RE: 2802 Sioux St NW
Grading & Drainage Plan
Engineer's Stamp Date: 11/24/2025
Hydrology File: H13D126
Case # HYDR-2025-00422

Based upon the information provided in your submittal received 11/24/2025, the Grading & Drainage Plan **is not approved** for Building Permit. The following comments need to be addressed for approval of the above referenced project.

ENGINEER'S SEAL	TRACT 81A3 RIO GRANDE CONSERVANCY DISTRICT MAP 35 2802 SIOUX STREET GRADING AND DRAINAGE PLAN	DRAWN BY DEM
		DATE 11-20-25
11/24/25		2802 Sioux Street.dwg
DAVID SOULE P.E. #14522		SHEET # C1
	P.O. BOX 53394 ALBUQUERQUE, NM 87199 (505) 321-8099	JOB #

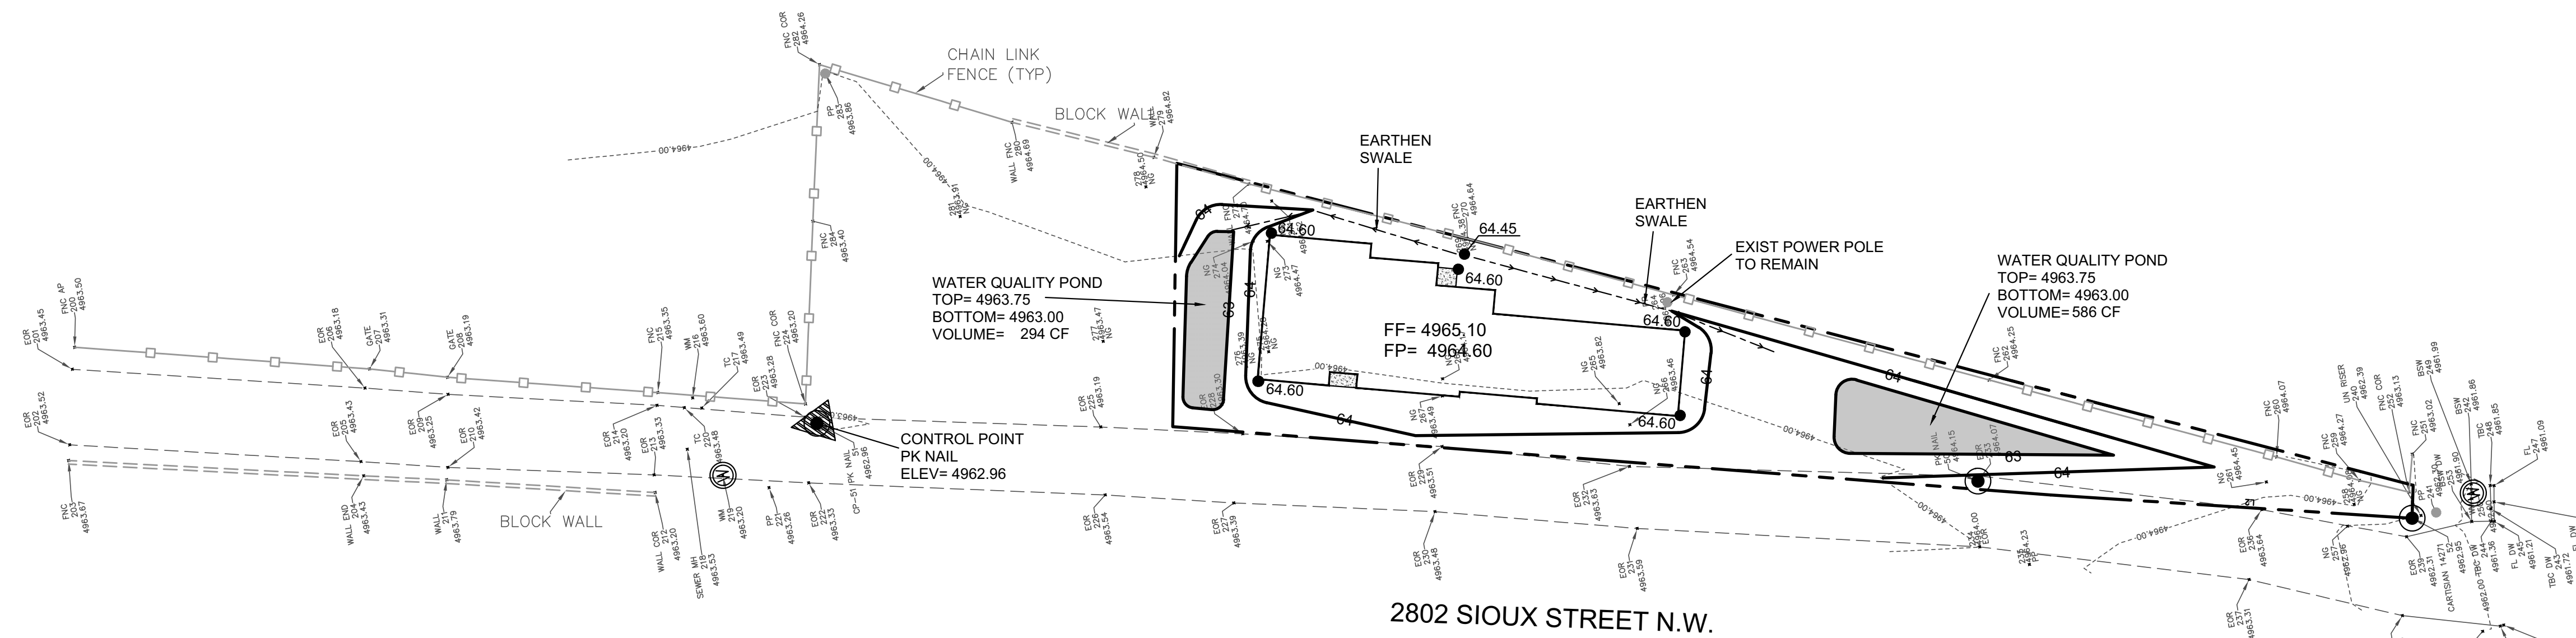
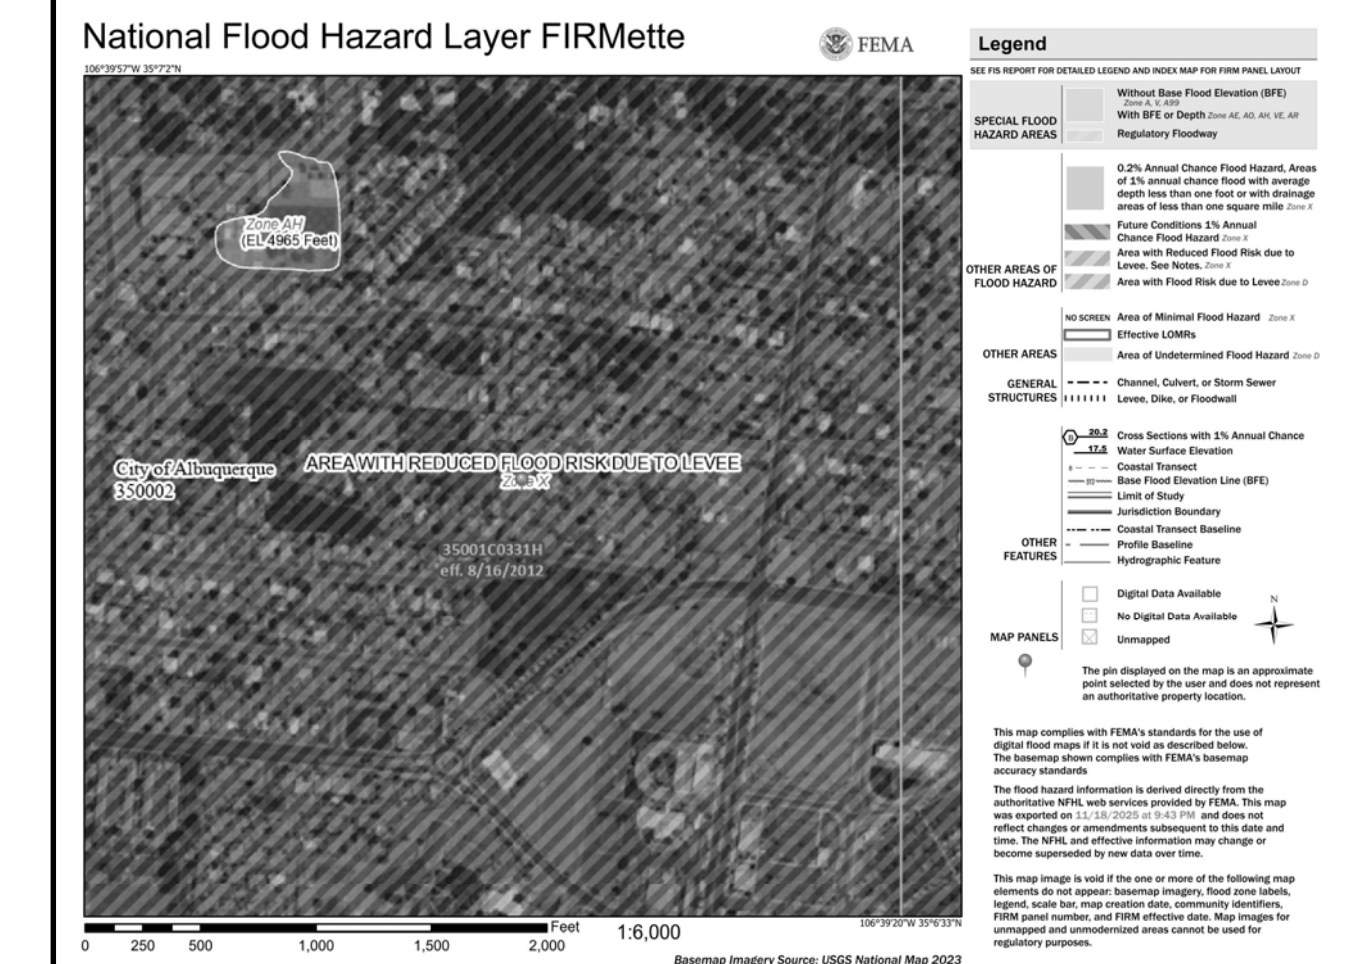
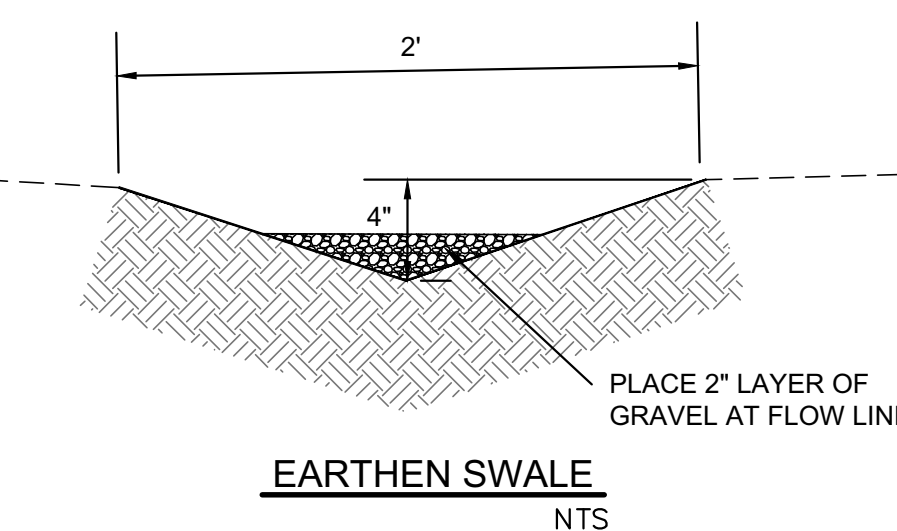
1. Per the IDO, the property owner of the property is responsible for building the adjacent half of Sioux Street to include curb & gutter, and sidewalk. The project will have to go to the Development Facilitation Team (DFT) for approval of the Infrastructure List.

2. Please show the curb & gutter, and sidewalk on the plans.
3. Stormwater discharges across the sidewalk are not allowed on collector roads and above; provide sidewalk culverts or drain lines through the curb.

4. Since this site is in the Valley region, please follow Article 6-5 Valley Drainage Criteria of the DPM. The following conditions must be applied to the site:

- a. Pad elevation shall be a minimum of one (1) foot above the 100 year 10-day stormwater surface elevation.
 - b. A permanent perimeter wall or barrier around the development is required to contain the 100 year 24 hour storm developed runoff.

5. Please provide the FIRM Map and floodplain note with effective date.
